STATE OF NORTH CAROLINA
DEPARTMENT OF TRANSPORTATION

SUBJECT: Application for Permit Modification to the Section 404 Individual Permit and Section 401 Water Quality Certification for the Proposed Replacement of Bridge Nos. 74 and 76 and Interchange Improvements Over SR 1242 and Michael Branch. Davidson County; Federal Aid No. BRSTP-29(10); State Project No. 8.1601401; TIP No. B-3157. \$475.00 Debit work order 8.1601401, WBS Element 32899.1.1 USACE 404 Individual Permit Action ID 200030843, issued September 7, 2004 NCDWQ 401 Water Quality Certification No. 3467, issues July 28, 2004

The purpose of this submittal is to request a modification to the Section 404 Individual Permit and Section 401 Water Quality Certification. The modification for the permit is for increased temporary impacts of 88 feet from the proposed channel diversion and revisions to Segment #3 of the stream relocation/restoration.

Part of
Plan sheet 5

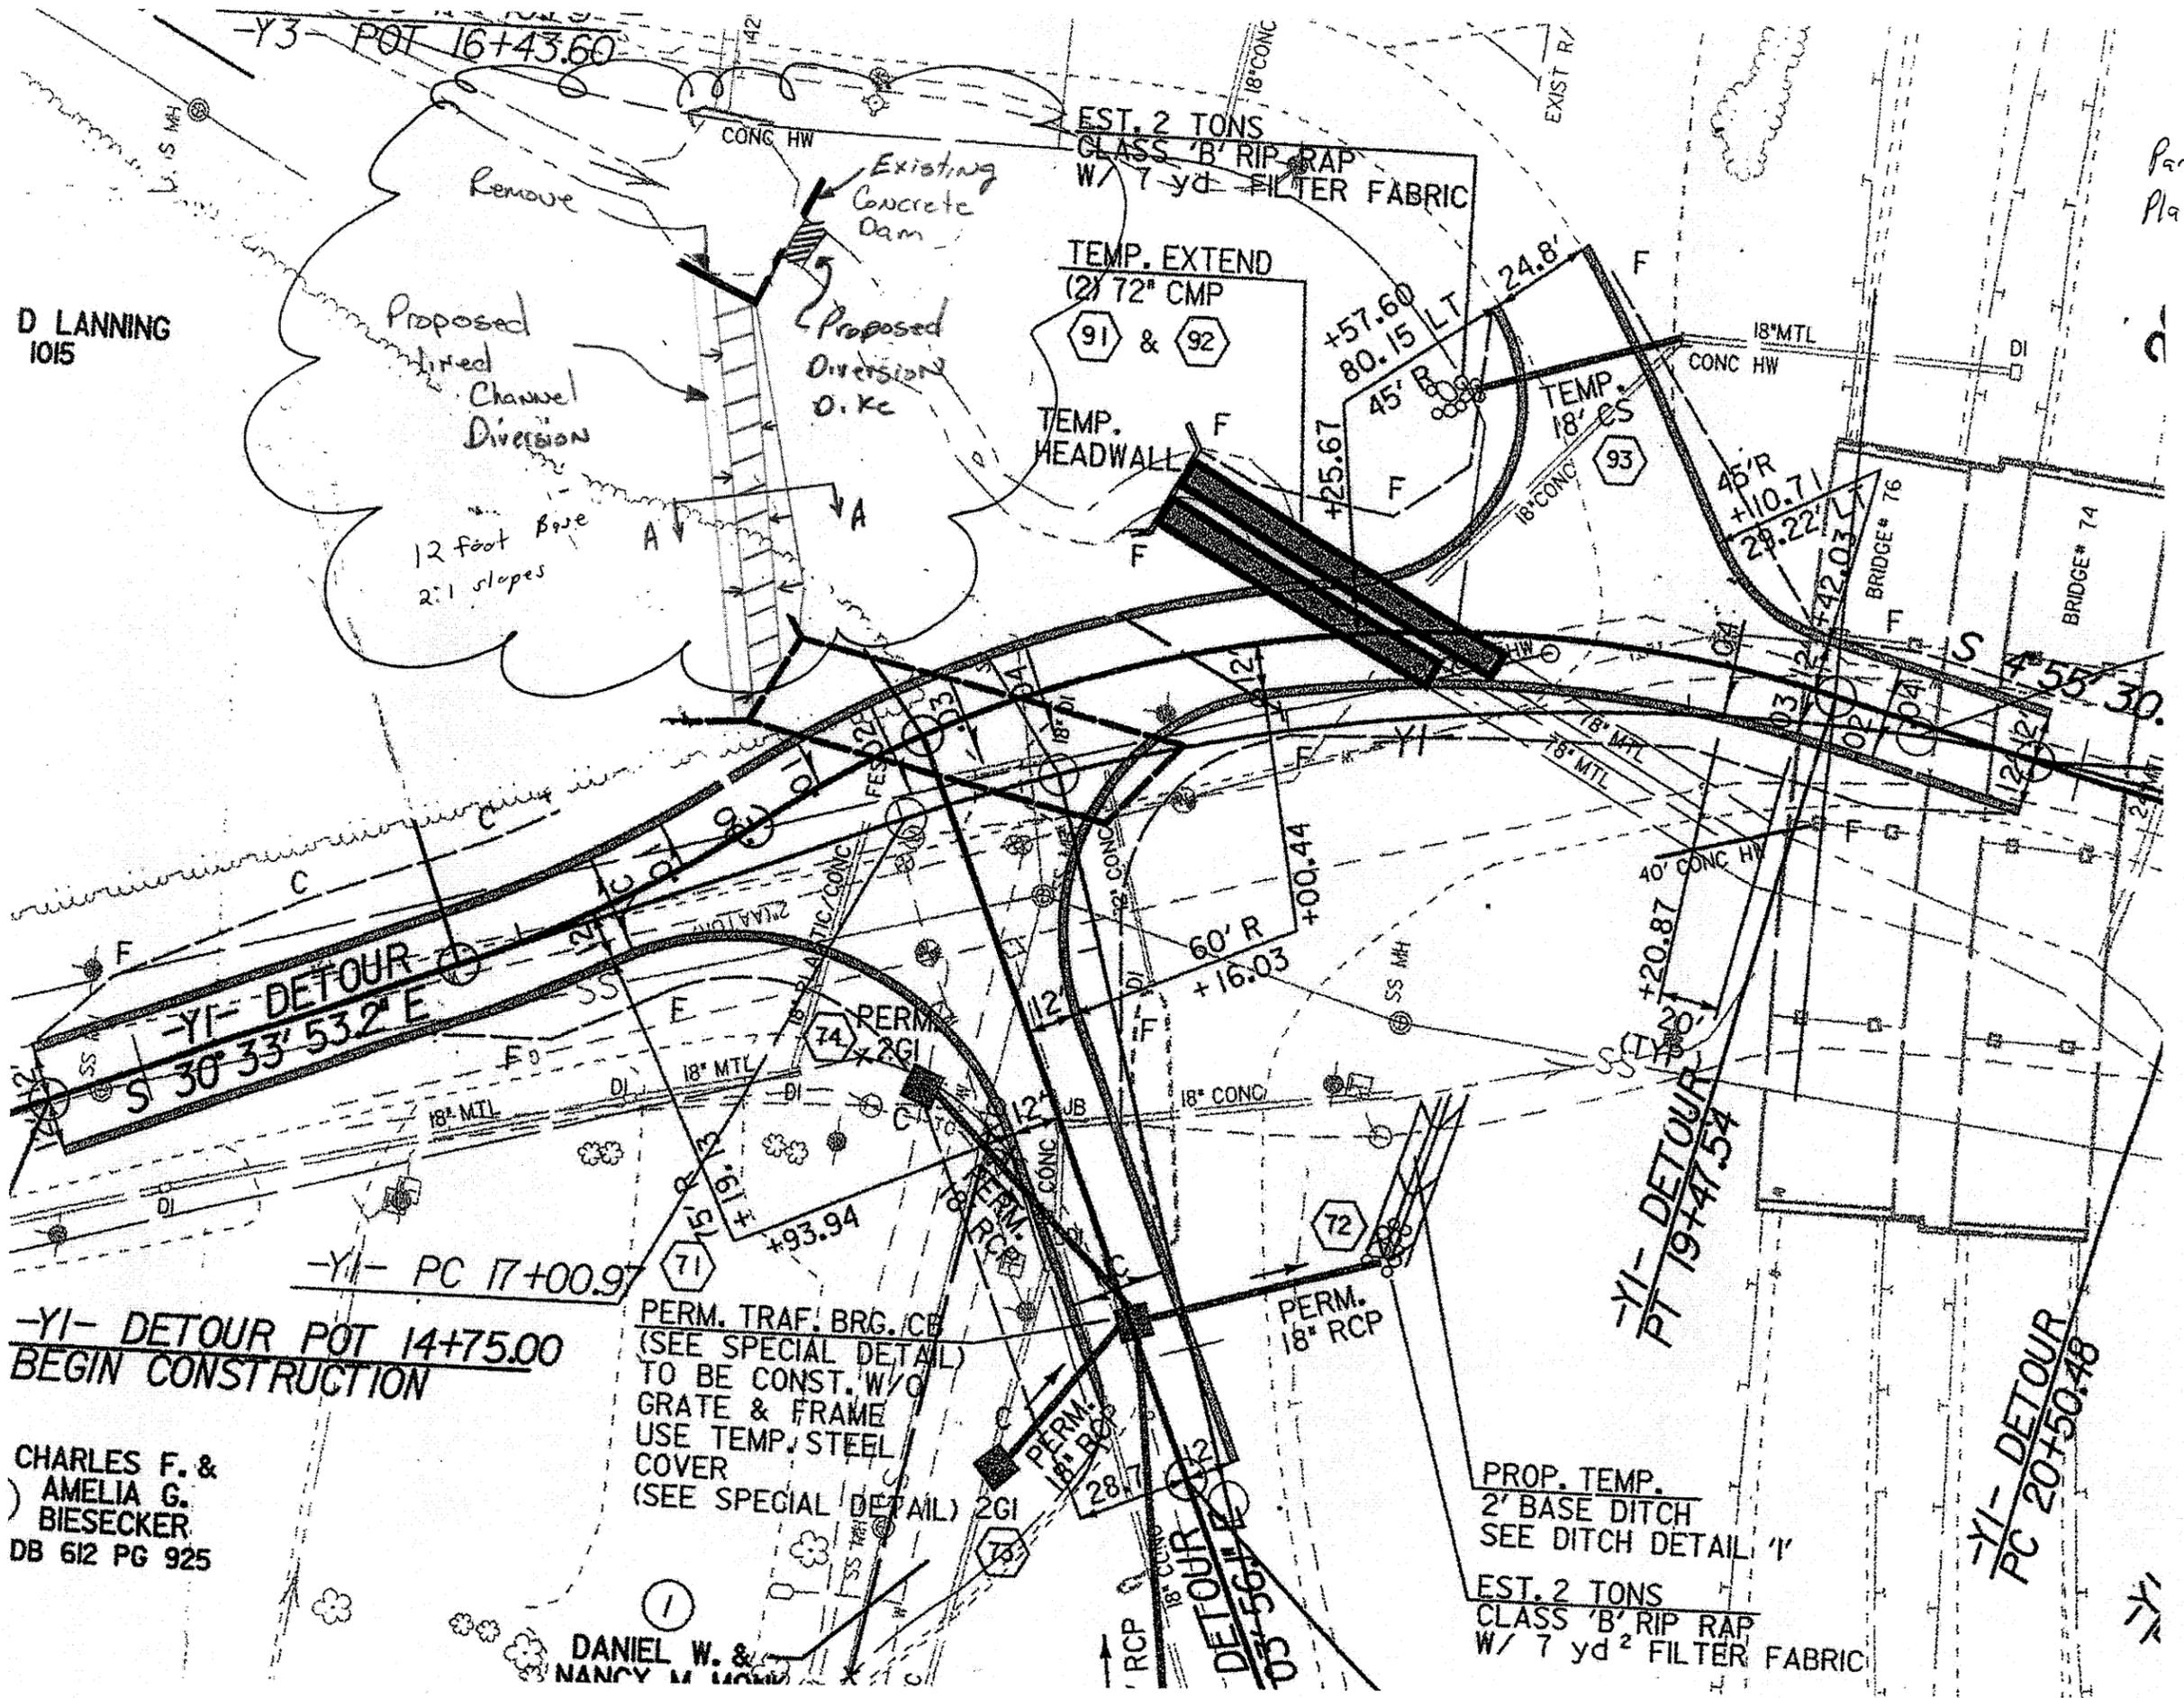
Proposed Channel Diversion/Permit Drawing 29 of 31/Plan Sheet 5

The diversion channel would be built and put into use just prior to the construction of temporary shoring that would block the flow of Michael's Branch in the existing 72 inch pipes and remain in use until segments #1 and #2 of the Natural Channel Relocation have been stabilized. At that time, which should be spring 2006, Michael's Branch would be put into the proposed natural channel relocation.

1. Excavate the temporary diversion channel from the culvert inlet to the existing concrete dam along the existing stream, while maintaining flow in Michael's Branch.
2. Line the temporary diversion channel with geotextile fabric
3. Once the temporary channel is lined, remove the existing concrete dam and turn the water into the lined diversion channel.
4. After the natural channel relocation is stabilized and the temporary channel is no longer needed it will be dressed, graded, and stabilized as part of the proposed floodplain.

The temporary diversion channel has a 12 foot base with 2:1 slopes. This temporary diversion channel will increase temporary stream impacts by 88 feet.

SHEET 20 OF 31
REV. 4/21/05

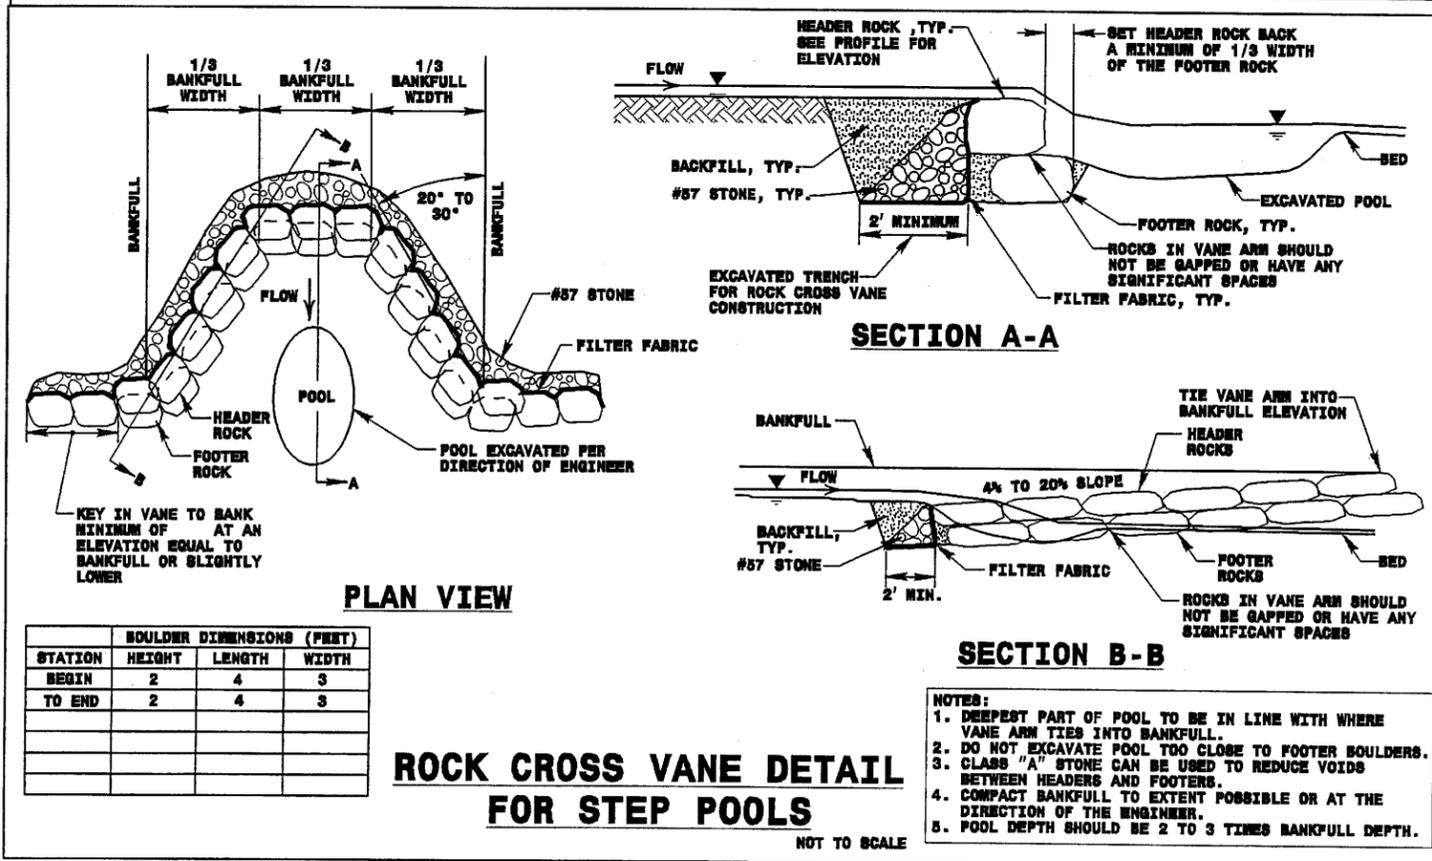
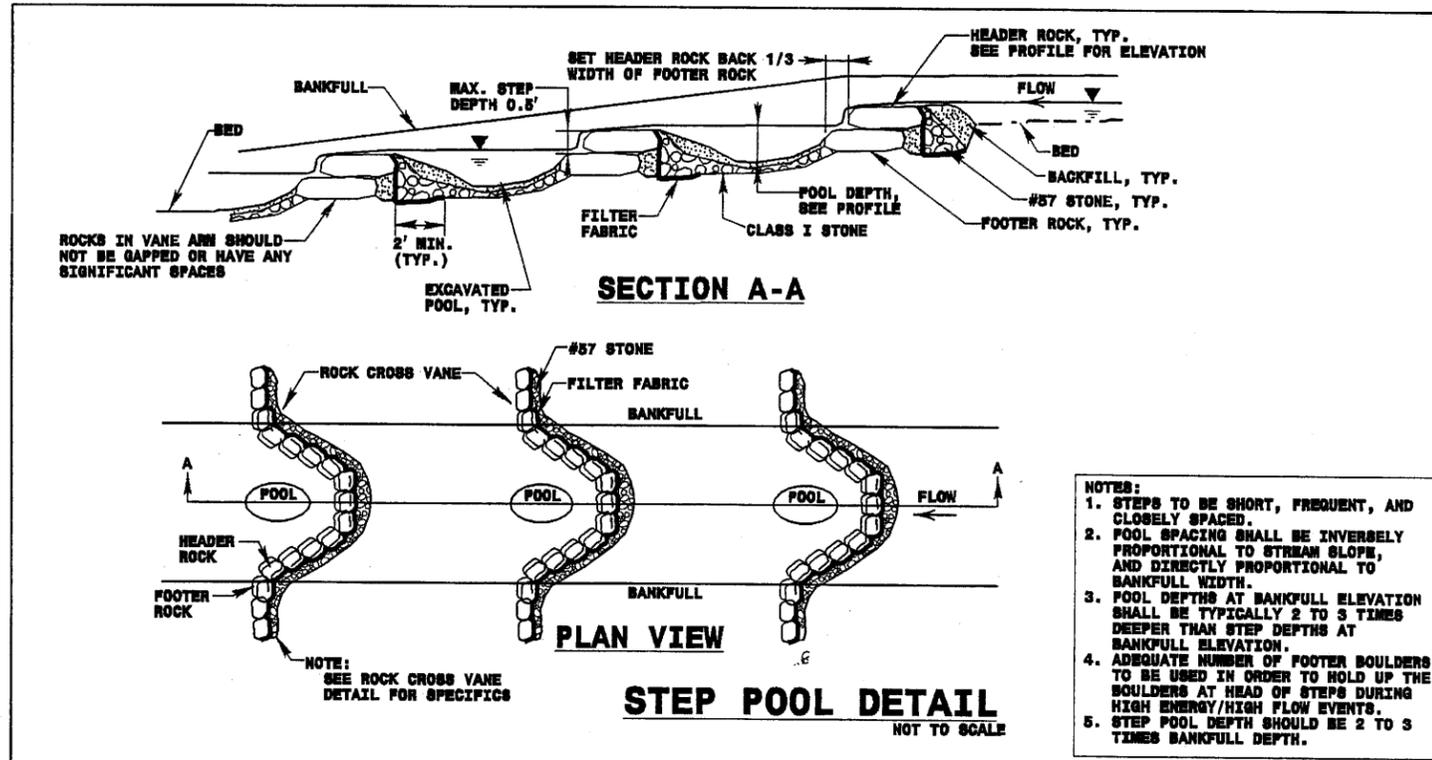
Segment #3 of the stream relocation/restoration/Permit Drawings 20, 23 and 24

Prior to the start of construction of the new stream channel in Michael's Branch, the Natural Environment Unit-Natural Environment Engineering Group reviewed the construction plans. At that time, it was determined that based on the valley slope, stream slope, and urban setting, the stream design needed to be a step-pool system instead of the riffle-pool sequence shown on the plans. The changes to the design consisted of reducing the sinuosity, the addition of rock cross vanes, and deletion of rock vanes. The typical sections of this project will remain the same with the only adjustments being made to the stream pattern and profile. On April 19, 2005, Army Corps of Engineers, Division of Water Quality, Wildlife Resource Commission, and NC Department of Transportation personnel met on site to review and discuss the proposed changes to the design. All parties were in agreement that these changes were justified. Per this meeting, and a letter dated April 21, 2005, enclosed are the proposed changes to Segment #3. This includes revised permit drawings for Natural Channel Design Typical (Sheet 23 of 31), Channel Plan View Segment #3 and Curve Data Information (Sheet 24 of 31). Segment #1 and #2 changes were submitted and approved in late April 2005.
